DEVIATION REQUEST AND DECISION FORM

Project Name : Flying Horse North Filing No. 3
Schedule No.(s) :
Legal Description :

A deviation in accordance with the Paving Season 2024 – UPDATED is requested.

JOB NO.
 231192
 FIG. 2

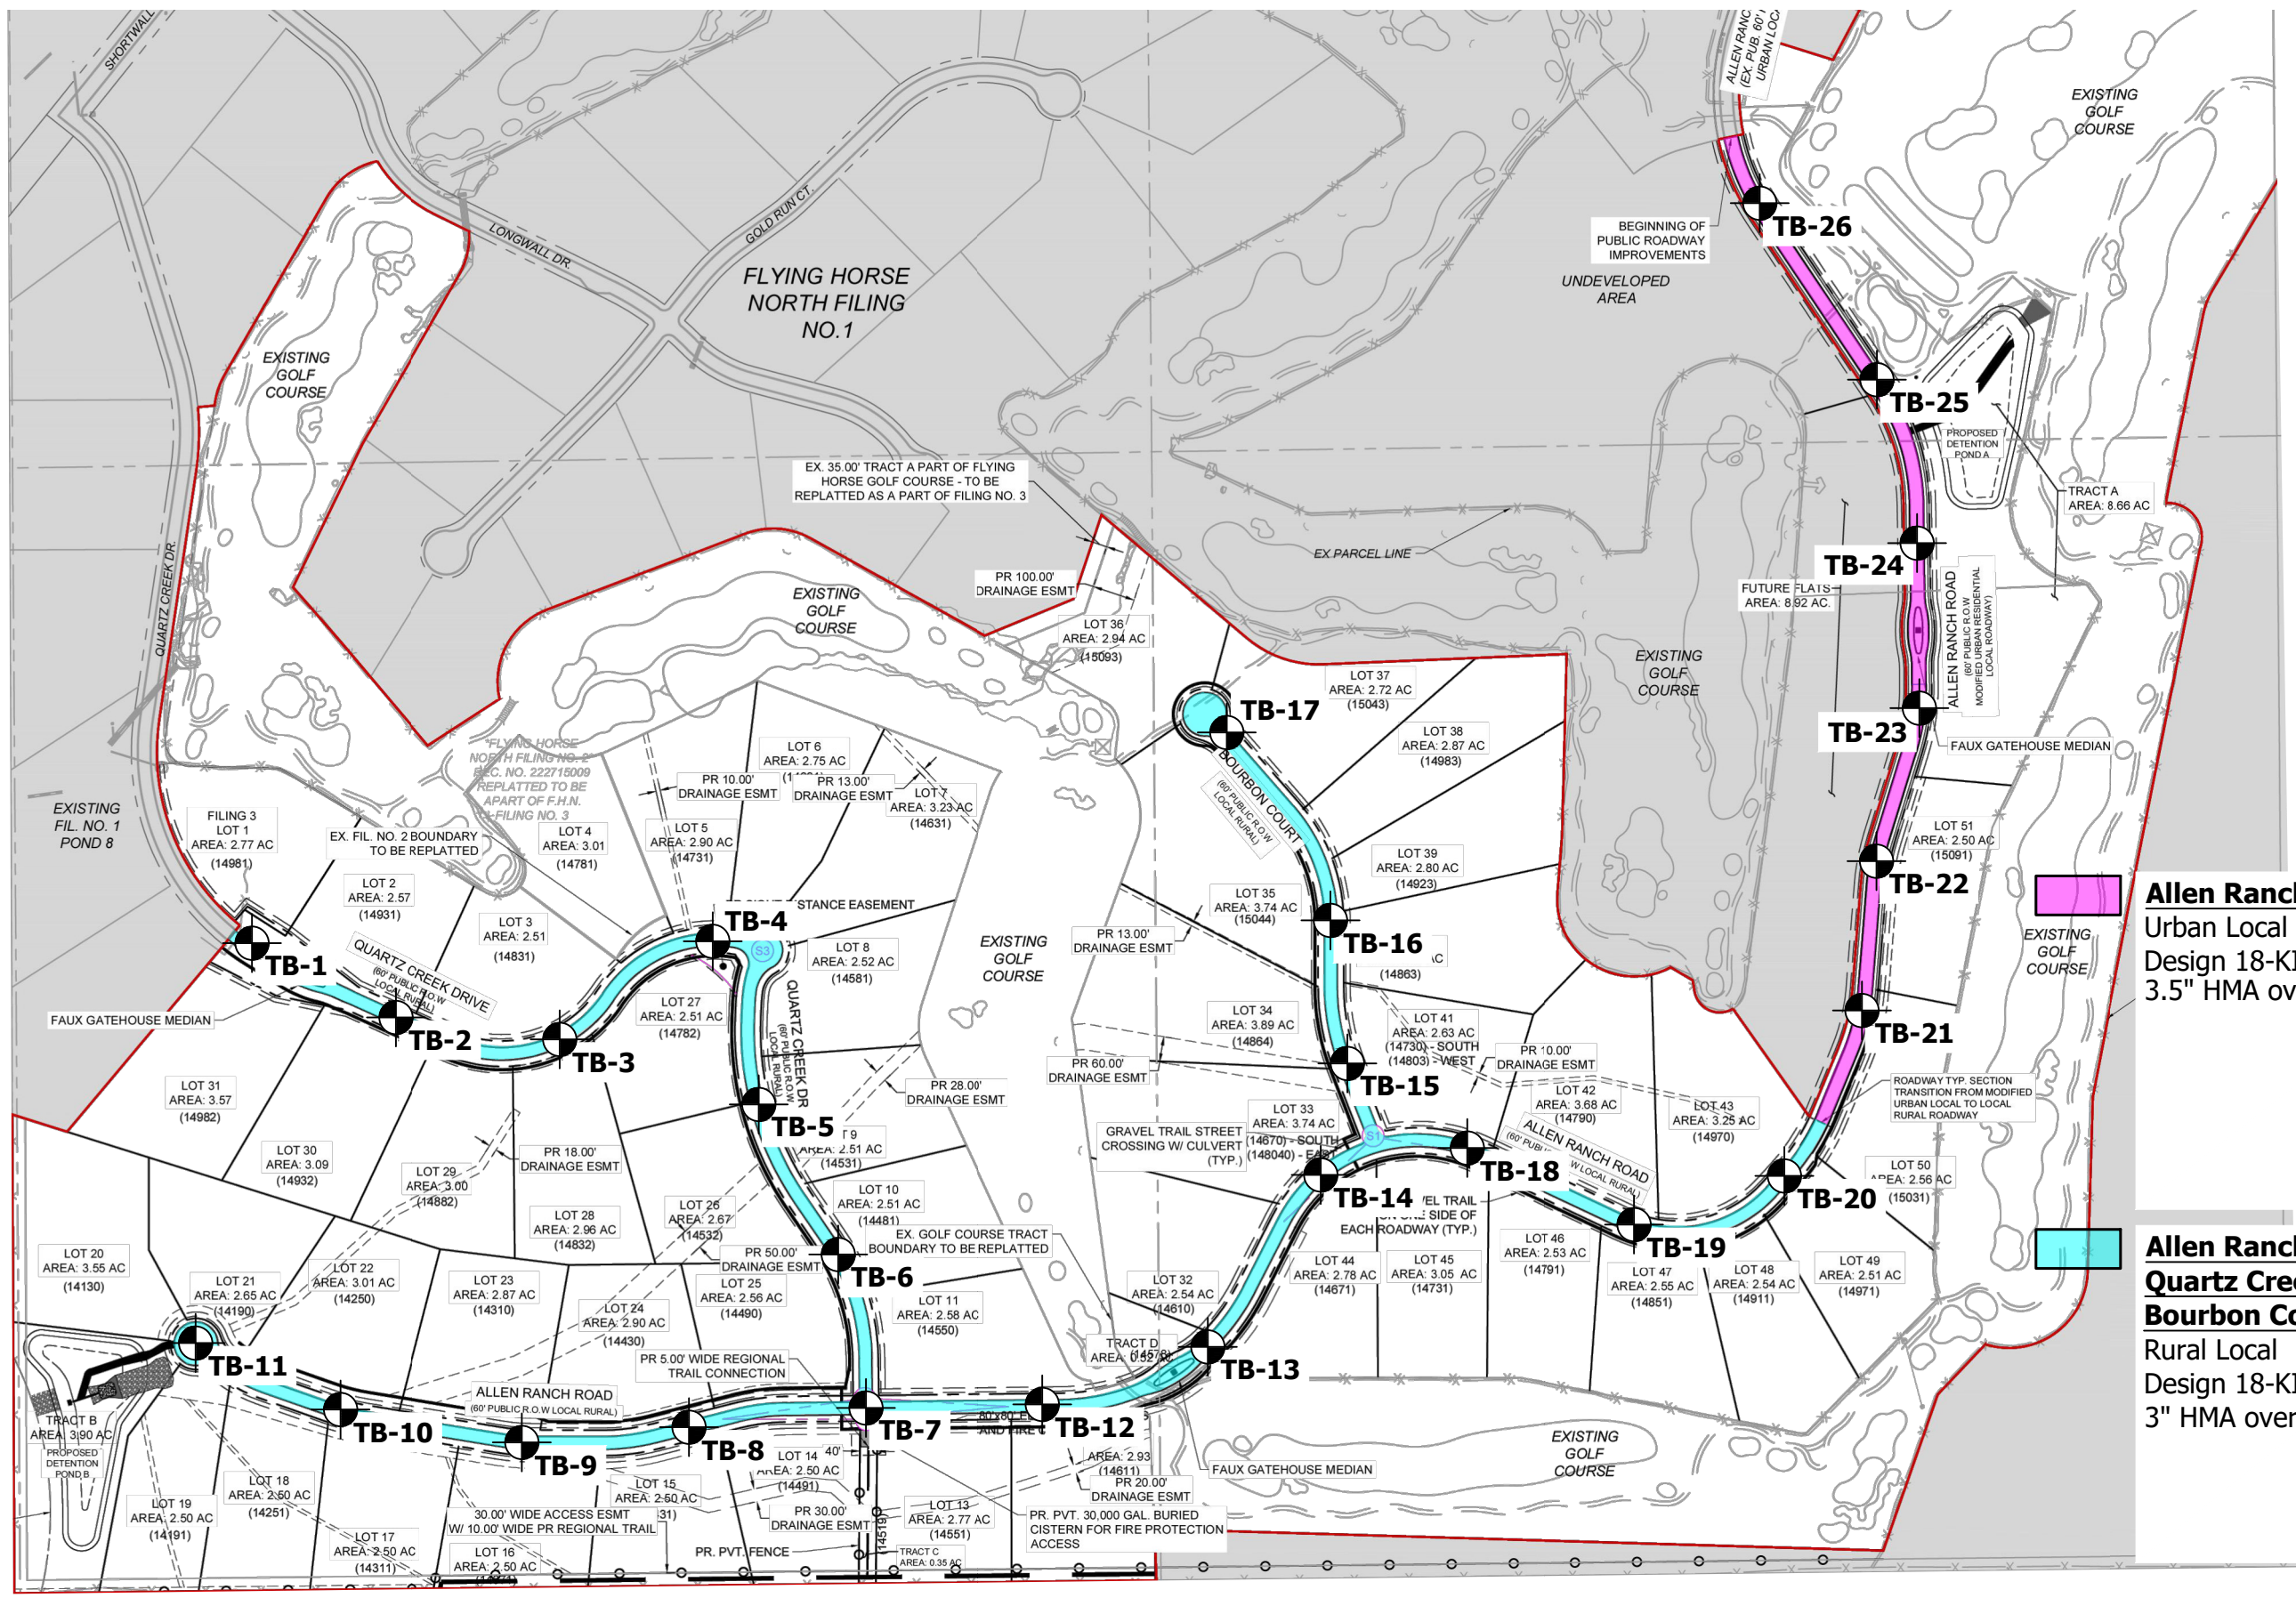
An exhibit displaying the areas to include CTS is attached with this deviation request.

Allen Ranch Road
 Urban Local
 Design 18-KIP ESAL=292,000
 3.5" HMA over 8" CTS

**Allen Ranch Road,
 Quartz Creek Drive,
 Bourbon Court**
 Rural Local
 Design 18-KIP ESAL= 36,500
 3" HMA over 4" CTS
